Comments to the Draft Guidelines for Accessible Public Rights-of-Way

I am writing as the chair of a committee of American Public Works Association members charged with updating a section of the Kansas City Metropolitan Chapter construction specifications and guidelines. This section deals with incidental construction and includes sidewalks and sidewalk ramps. I have tried to reflect the views (which are varied) of the committee members. A draft of this document was distributed to the committee, but due to time constraints, this final document was not. I believe I have represented a consensus view, but will take full responsibility for these comments since the committee did not review this final draft.

Figure 1 Light Frequency Response Curve from Kodak gray card package

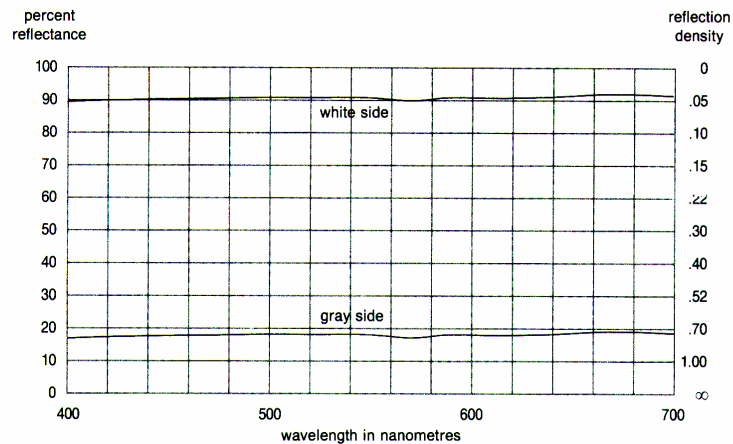
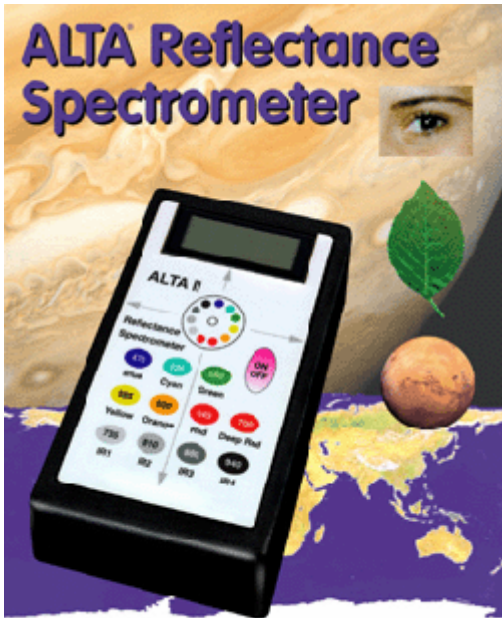
Photographers use a Kodak gray card to establish exposure. These cards have a white side that is 90% reflective, and a grey side that is 18% reflective. This reflectance is essentially constant across the spectrum of visible light frequencies.

Note that a 90% reflective white is a brighter white than most office copy/printing paper. In our office, the Georgia Pacific copy paper has a brightness of 84%. For the Kodak gray card, and using Equation 1 above, the contrast is 80%. Given the gray cards essentially flat frequency response, that contrast ratio is constant across the visible light spectrum.

Figure 2 - Selected Concrete Reflectance

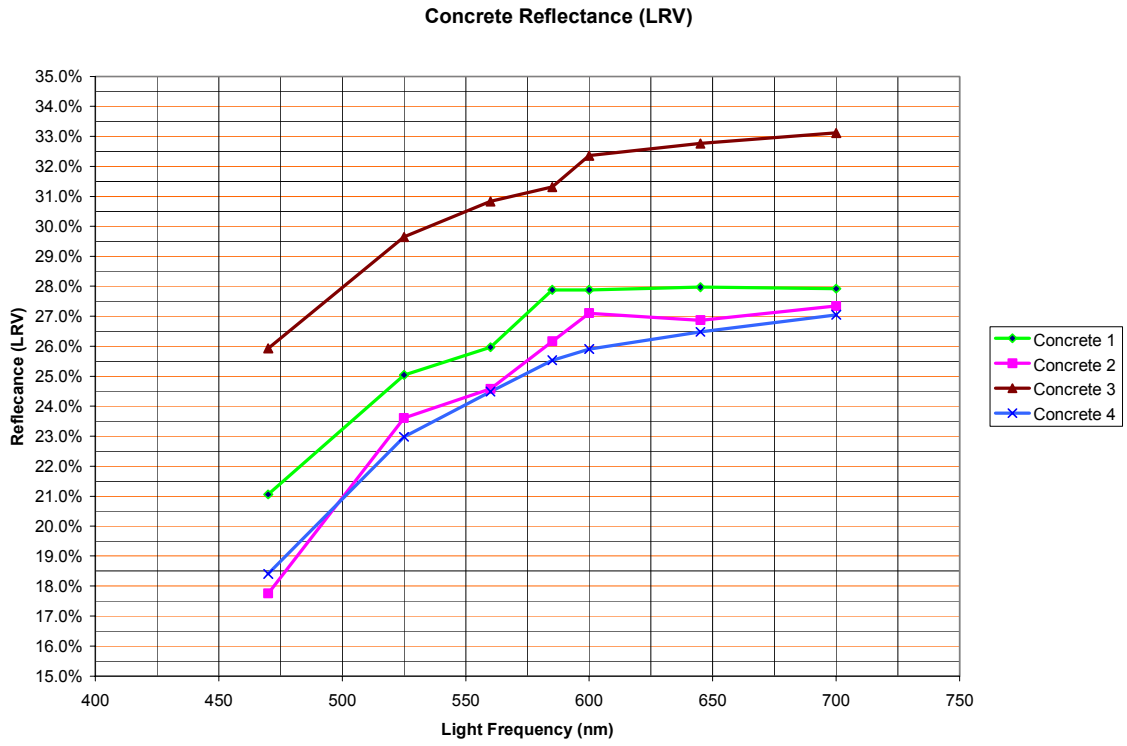
We tested four sidewalk panels. All were concrete, and the age varied among the four from new to nearly 20 years old. The newer concrete is labeled “Concrete 3” in Figure 2 below. The higher reflectance is at least partly attributable to the white curing compound that was still visible on the surface of the concrete. If we select a “dark” LRV of 25%, in order to meet 70% contrast, the “light” value would need to be at least

This would require a “light” only slightly less white than economy white office paper. With the newer concrete and assuming a LRV value of 30% (which is a darker value than the reflectance across most of the spectrum) the “light” color would need to have a LRV of 100% which is obviously not attainable new or after the materials had aged.

If a visual cue is important, I'd recommend that the end of the ramp be marked with white thermoplastic or other similar pavement marking materials. This material is retro-reflective (has embedded glass beads that reflect light) and would provide a high degree of contrast against the darker concrete (at least while new).
